Executive Director's Recommendation

PROJECT Text Amendments to Rooftop Penthouse Regulations Washington, DC	NCPC FILE NUMBER ZC 14-13 NCPC MAP FILE NUMBER 00 00(06 00)44194
SUBMITTED BY Zoning Commission of the District of Columbia	APPLICANT'S REQUEST Approval of report to the Zoning Commission of the District of Columbia
REVIEW AUTHORITY Approval of Comments to the Zoning Commission of the District of Columbia	PROPOSED ACTION Approve comments as requested ACTION ITEM TYPE Consent Calendar

RE: NCPC Staff Comments on ZC 14-13, Text Amendments to Rooftop Penthouse Regulations

Recommendation

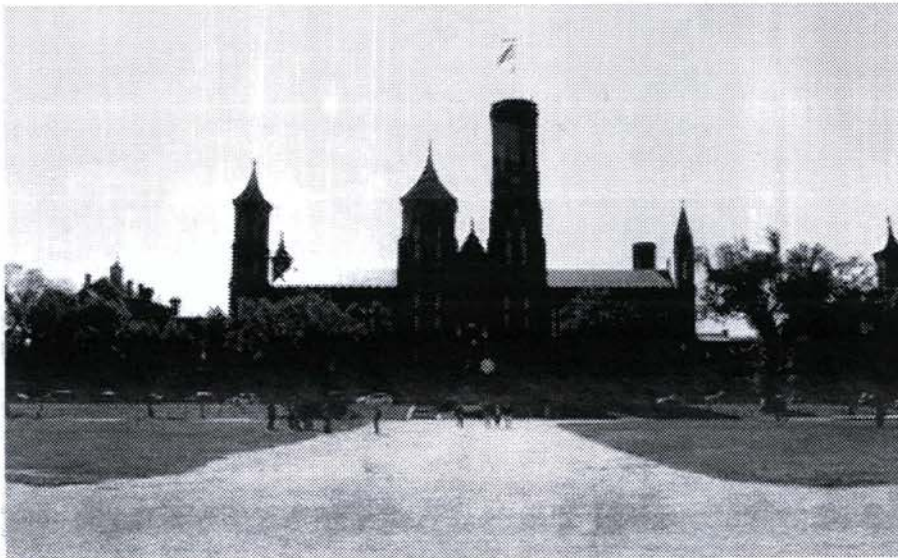
Based on this most recent application of square guidelines and the majority of buildings along the Avenue today, NCPC staff believes that penthouse related uses should be incorporated into the 160' building height, consistent with the overall guidance in the PADC plan.

NCPC staff proposes that no penthouses (both mechanical and habitable) be allowed on 160' buildings within the PADC boundary (squares fronting Pennsylvania Avenue between 3rd and 15th Streets, NW) unless otherwise allowed through individual square guidelines in the Pennsylvania Avenue Development Plan.

View of the Smithsonian Castle today from the center of the National Mall.

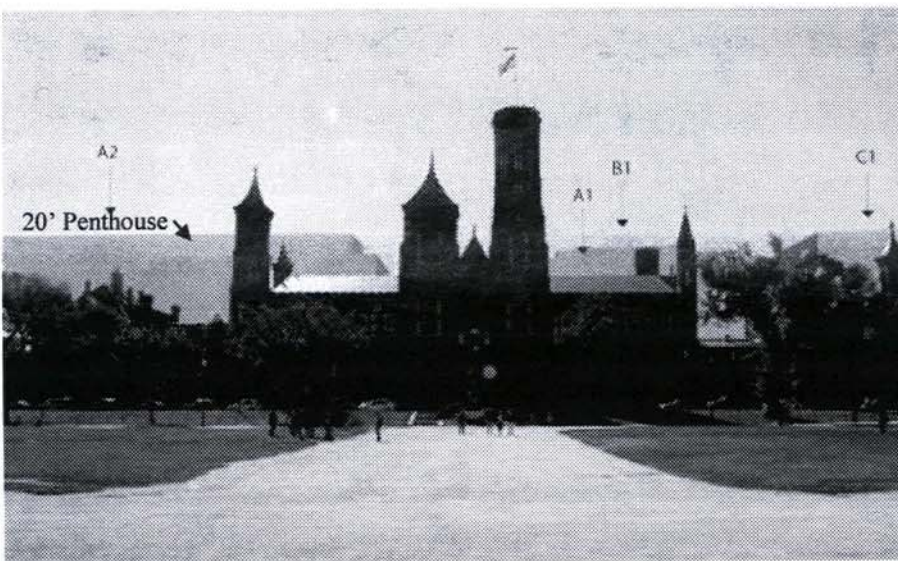
NCPC staff identified concerns with the proposed penthouse regulations for both the current and proposed zoning on Independence Avenue between 6th and 12th Streets, SW. Current zoning allows buildings on Independence Avenue a matter-of-right height of 90' and 130' through the Planned Unit Development (PUD) process. The DCOP's proposed zoning in the Zoning Regulations Review (ZRR) allows buildings on Independence Avenue a matter-of-right height of 130' with an upper story step-back at 110' (in addition to a building line setback of 88' from Independence Avenue). Today, the National Mall is a public space within a park-like setting framed by trees and civic institutions as opposed to private development. The two images below show the impact of a 20' penthouse on top of 130' buildings on Independence Avenue as seen from the National Mall.

View of the Smithsonian Castle with new buildings at 130' in height with a 20' penthouse (total height of 150').

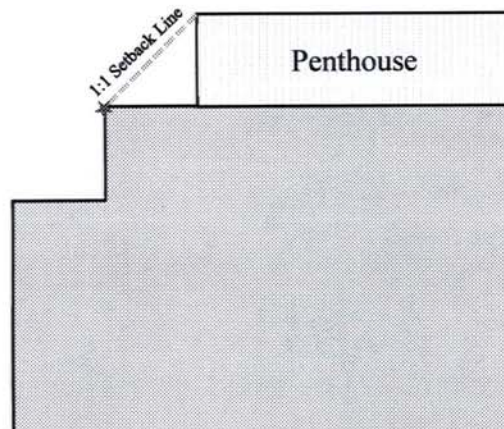
As previously indicated in staff's oral and written testimony to the ZC, any development over this 130' height (whether mechanical or habitable penthouses) would negatively impact the public open space views from the National Mall.

NCPC staff proposes that no penthouses (both mechanical and habitable) be allowed.² All rooftop equipment and mechanical structures should be incorporated into the 130' building. Any penthouse development over 130' negatively impacts views of the Smithsonian campus and views from the National Mall.

Special Exceptions

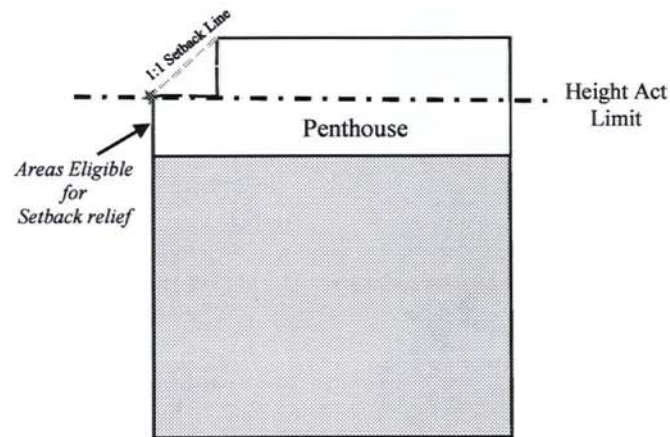
The proposed regulations in §411.11 would allow the BZA to grant relief from penthouse setback requirements under certain conditions. NCPC staff recommends clarifying in the proposed zoning regulations that only the portion of the penthouse under the limit of height of the Height Act would be eligible for setback relief and the height above the limit would require the 1:1 setback (as shown in the image below).
